**Technical Service Bulletin (TSB)**  
**Easy Entry Seat Function not Locking in Place**

<b>REFERENCE:</b>	<b>TSB:</b> 23-088-23 REV. A <b>GROUP</b> 23 - Body	<b>Date:</b>	August 30, 2023	<b>REVISION:</b>	23-088-23
<b>VEHICLES AFFECTED:</b>	<b>2023 (JL) Jeep Wrangler</b> This bulletin applies to vehicles built on and after <b>**August 15, 2022 (MDH 0815XX)</b> and on or before <b>May 24, 2023 (MDH 0524XX)**</b> that are Two Door vehicles (Sales Code 5ZS).	<b>MARKET APPLICABILITY:</b>			
<b>CUSTOMER SYMPTOM:</b>	One or both front seats can become stuck in the tumble forward or easy entry position. If this occurs on the driver side, the vehicle will not be able to be driven (the seat back will be locked forward).				
<b>CAUSE:</b>	Fore/Aft seat position returns (memory stone) is breaking.

**Fig. 1**  
**Seat Position Return Removal**

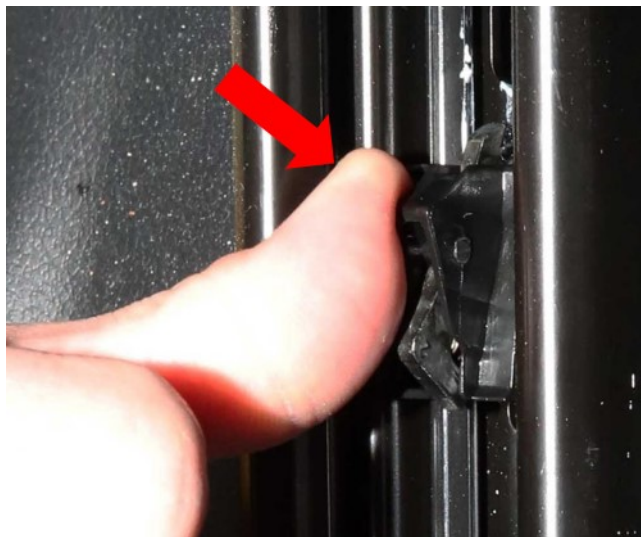
1. Remove the seat position return from the seat track by positioning your thumb at the side of the peak on the seat position return (Fig. 1), applying lateral pressure pushing towards the center of the vehicle and popping it out of the seat track. Discard the seat position return.

Fig. 2

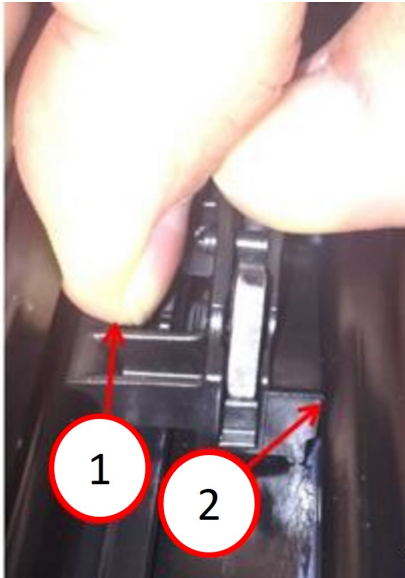
2. Insert the new seat position return corrugated side first, into the seat track (Fig. 2) .

3. Install the new seat position return by placing one finger on the peak and a second finger on the open cavity side, pushing the seat position return straight down into the seat track (Fig. 2) .
4. Take one finger and press on the rear raised metal insert (Fig. 3) and slide the seat position return fore and aft in the seat track. Make sure the seat position return slides easily in the seat track.
